Subject: AP1000 COL Response to Request for Additional Information (TR 36)

Response to Request for Additional Information on Technical Report No. 36

RAI Response Number: RAI-TR36-012

## Response to Request For Additional Information (RAI)

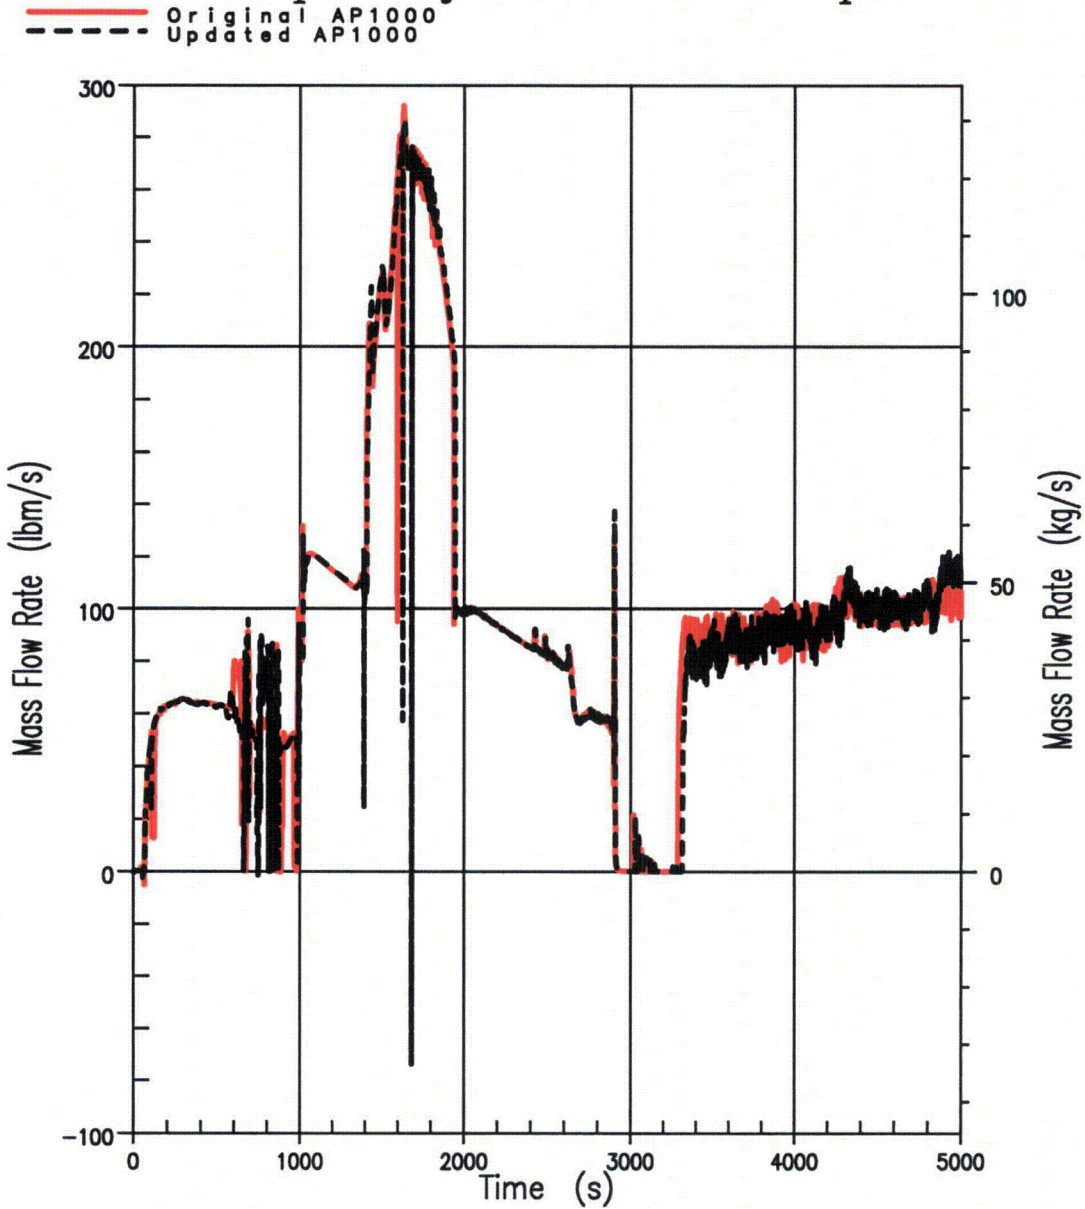
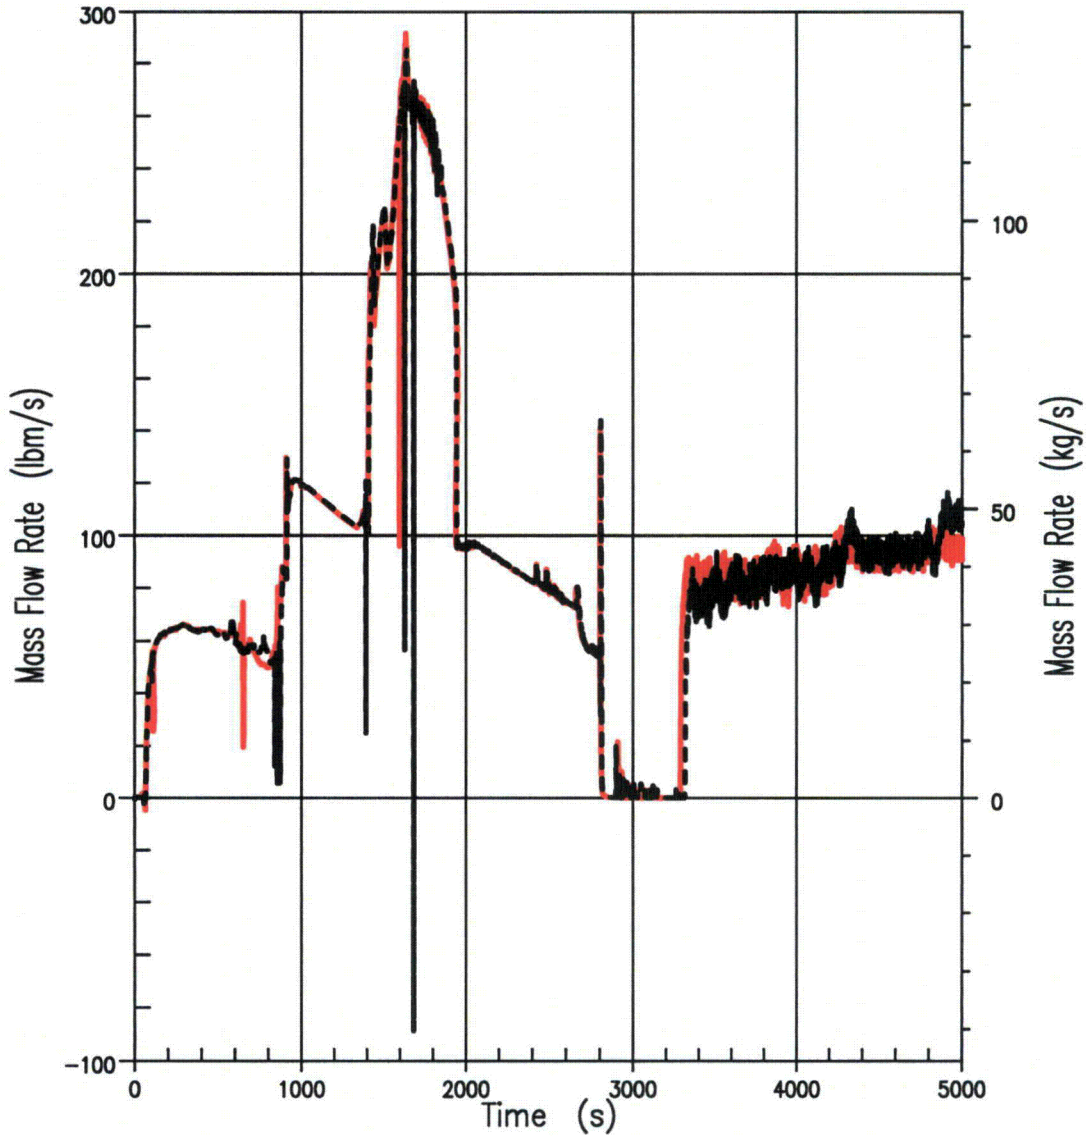
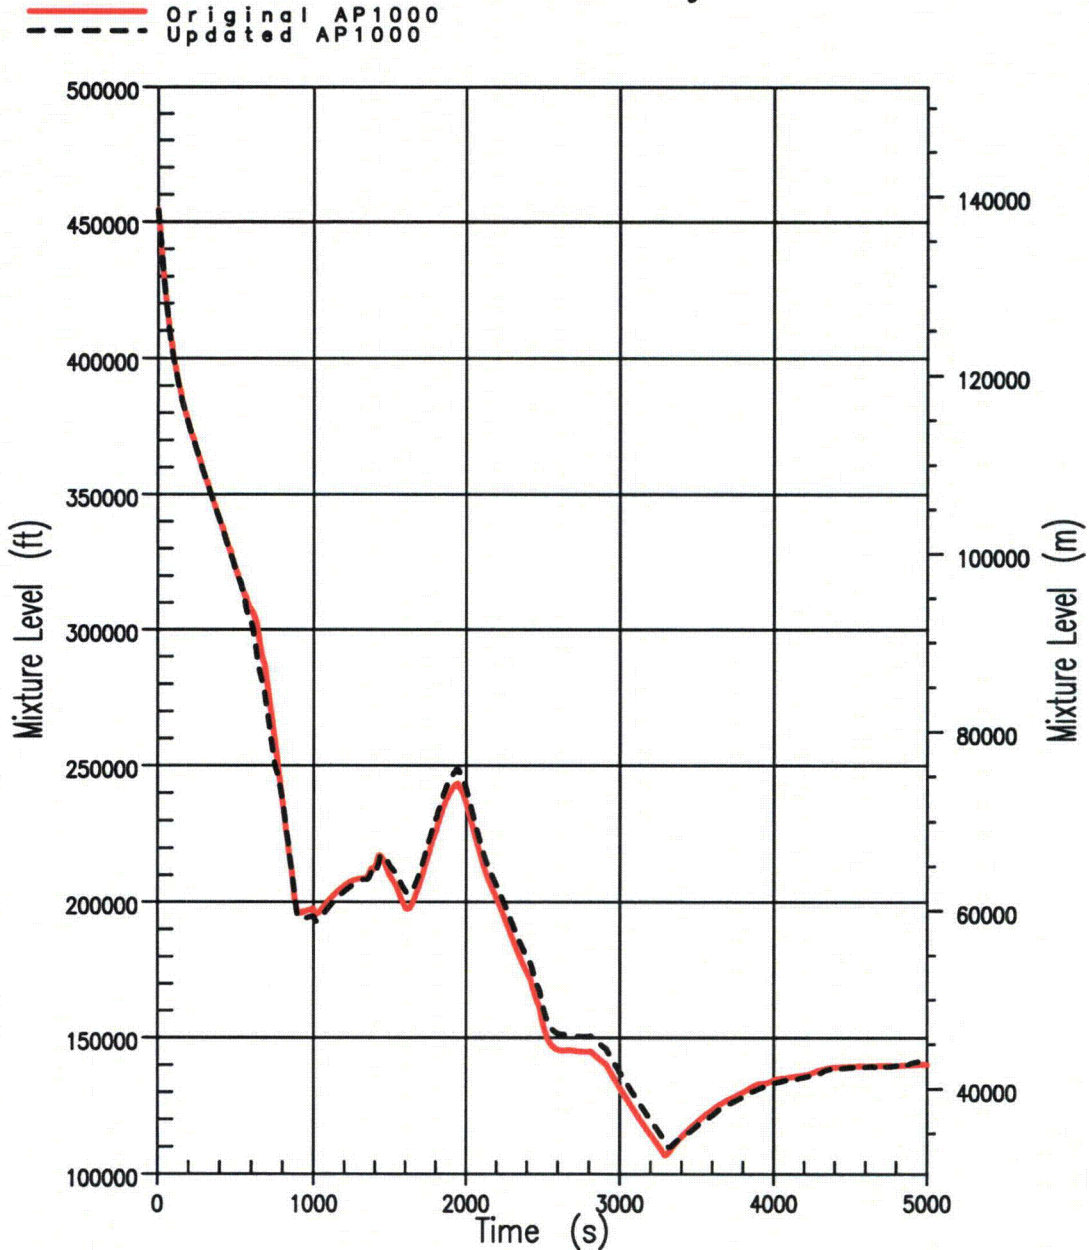
The pressurizer changes affect many parameters such as the cross-sectional area of the pressurizer, pressurizer vessel height, initial pressurizer water level, pressurizer setpoints, ADS stages 1, 2, and 3 elevation and pressurizer heater length. We are concerned about the combined effects of the values changed for the above parameters on the thermal hydraulic response during transient and accident conditions. We determined that the qualitative statement in the RAI response is not sufficient to resolve the RAI issue. We request Westinghouse perform the quantitative analyses for the limiting event for each of the following Standard Review Plan chapter 15 event categories:

Table 6.3-2 and Figures 6.3-10 through 6.3-19 present a comparison of the 2-Inch Cold Leg break simulations. The results again demonstrate the effect of the change in the pressurizer tank diameter, that being the decrease in both the Pressurizer Mixture Level (Figure 6.3-13) and Pressurizer Void Fraction (Figure 6.3-14). This subsequently reduces the Automatic Depressurization System (ADS) Stage 1-3 liquid discharge (Figure 6.3-15) and increases the ADS 1-3 vapor discharge (Figure 6.3-16). The overall effect being slightly more Reactor Coolant System (RCS) inventory in the RCS for a majority of the transient simulation period (Figure 6.3-19). No significant changes in the RCS Pressure (Figures 6.3-10 and 6.3-11), Core Mixture Level (Figure 6.3-12) and DVI injection characteristics (Figure 6.3-17 and 6.3-18) are observed as a result of the design change implementation.
